HSIN DA PRECISION CO., LTD
Liyang Xinda Precision Electronics Co., Ltd.

NOTICE OF HSIN DA 946 SERIES

Date : Nov. 30, 2018

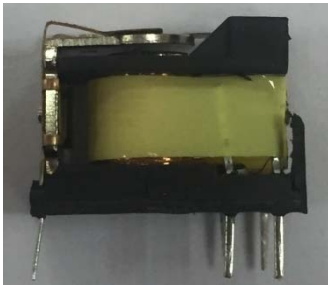
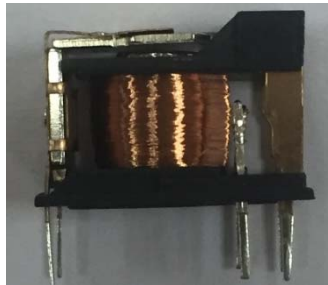
ITEM	BEFORE	AFTER
Cover	a matte black cover with ink marking	a gloss black cover with laser print

Coil	24VDC coil was rapped with a tape	24VDC coil without a tape

Packing	PVC tube : 25pieces TUBE:420mmL×12.5mmW×17.5mmH 	PVC tube : 25pieces TUBE:410mmL×12.5mmW×17.5mmH 
	Corrugated inner box: 40 PVC tubes (1000 pcs relay) BOX: 425mmL×135mmW×75mmH 	White paper inner box: 20 PVC tubes (500 pcs relay) BOX: 415mmL×130mmW×37mmH 
	Corrugated shipping carton : 4 inner boxes (4000 pieces relay/Carton/ G.W,14 kgs) Carton: 440mmL×273mmW×230mmH 	Corrugated shipping carton : 4 inner boxes (2000 pieces relay/Carton/ G.W:7kgs) Carton: 470mm L×305mm W×130mmH
